# Technical Service Bulletin

## 61 Blistering in paint on carbon composite panels

61 13 19 2033516/2 June 13, 2013. Supersedes Technical Service Bulletin Group 61 number 13-18 dated June 12, 2013 for reasons listed below.

Model(s)	Year	VIN Range	Vehicle-Specific Equipment
R8 Spyder	2012	All	Not Applicable

**Figure 2.** Areas of the cover that are affected.

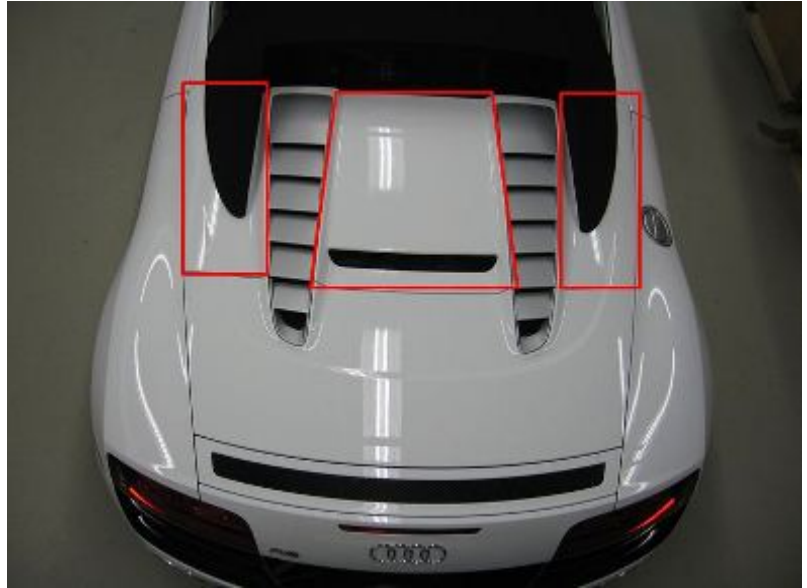
- Convertible top compartment cover (Figure 2)

Due to a malfunction during the resin injection process in the manufacture of these panels, the painted surface of the panel may blister under certain environmental circumstances.

Should the blistering condition described in this TSB be discovered, the vehicle will need to be transported to your Authorized Audi R8 Body Shop as the affected panel must be **replaced**. The panel cannot be refinished as recurrence of this paint condition is likely if an affected panel is refinished.
